Access Compliance Report Public Rights-of-Way (Curb Ramps)

Main Street: ST_GILES_CT Cross Street: ST_IVES_WAY Location: SW

ADA ID: RPRK211115115116 Ramp Type: Type 4 - Parallel Initial Pass/Fail: Pass Overall Compliance: No Severity Score: 20

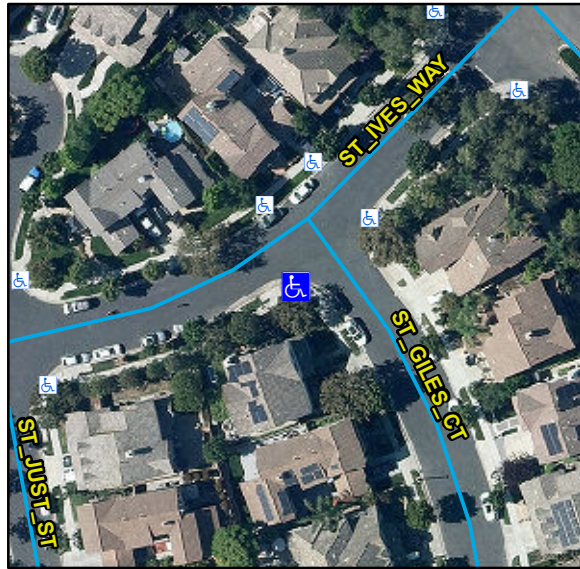
R204.3, R304.2.1, R304.2.2-Perp, R304.3.2-Para, R304.5.3, R305, STD 1115

Remove & Replace Curb Ramp With Two New Directional Ramps or Equivalent.
